DEPARTMENT OF PLANNING & URBAN DEVELOPMENT

Re; Lots 14 and 15 Avalon Road

Your application to construct a 2 family dwelling has been reviewed and a permit is herewith issued subject to the following requirements:

BUILDING PERMIT REPORT

ERMIT ISSUED

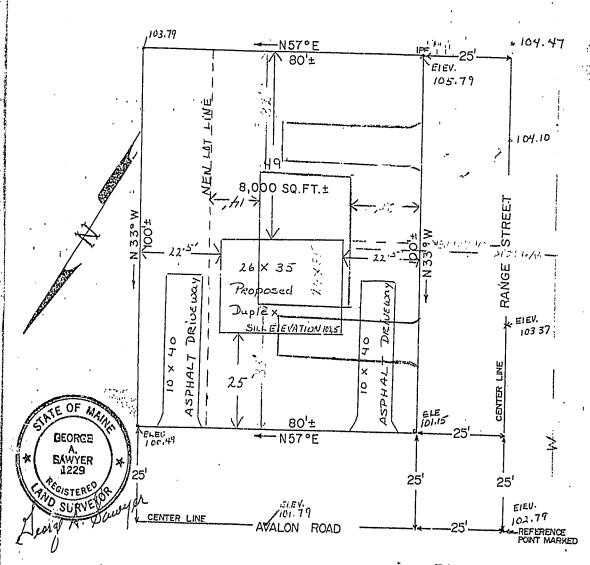
turning huildi	ng to face Range Stre	et			
as per plan					
А					
•			!		
	Details	of New W		4	
Is any plumbing involved in				lved in this work?	
Height average grade to to	p of plate	Height aver	ectical work live	st point of roof	_
Size, front depth	No. stories	eolid or f	illeg langs ike krade to tilkte	earth or rock?	
material of loungation	Thiolm:	occ ton	h - 44	••	
Material of underpinning_	THICKI	Hoight	bottom	cellar	
Kind of roof	Rise per foot	Doof and		Thickness	<u> </u>
No. of chimneys	Material of chimneys	11001 COV	ermg	of lining	-
Framing lumber - Kind _		Dragged o	- G.U -10	of lining	-
Corner posts	Sills Girt or lade	tor boards	r tun sizer	Size	
GirdersSize	Columns under di	rdoro	0'	Size Max. on centers	_
Studs (outside walls and ca	arrying partitions) 2x4-16" O	C Duideine i	Size	Max. on centers	
Joints and rafters:	1st floor	ନ୍ଦ୍ର Dridging I	n every Hoor and	lat roof span over 8 feet.	
On centers:	let floor	ond	, 3rd	, roof

for Range At duples in \$52 one Bill approves sensed plot plan as
